Group of Experts for the revision of the IMO/ILO/UNECE Guidelines for Packing of Cargo Transport Units

Proposals for amendments to the final draft of the CTU Code:

Proposal regarding boxes and crates

Transmitted by the expert of Sweden

Examples of typical boxes and crates, illustrating the difficulties in making sure that the cargo is properly secured.

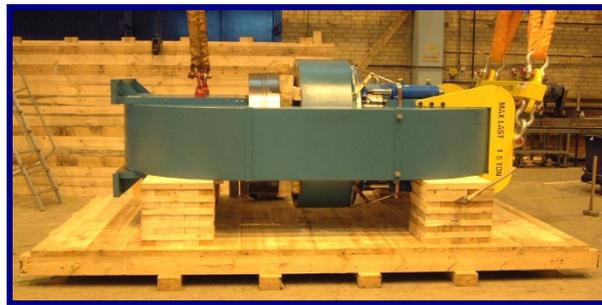
In intermodal transport utilizing RoRo and container vessels, cargoes such as heavy machinery are often packed in wooden boxes or crates. Securing these boxes and crates in a safe manner is not possible unless the cargo itself is well secured within the package. However, access to the cargo within is mostly not given to anyone in the transport chain other than the packers of the cargo, same as e.g. for cargoes inside sealed containers.

Thus, boxes and crates should be considered as Cargo Transport Units and the same principles and responsibilities for securing the cargo within them as for other CTUs should apply.
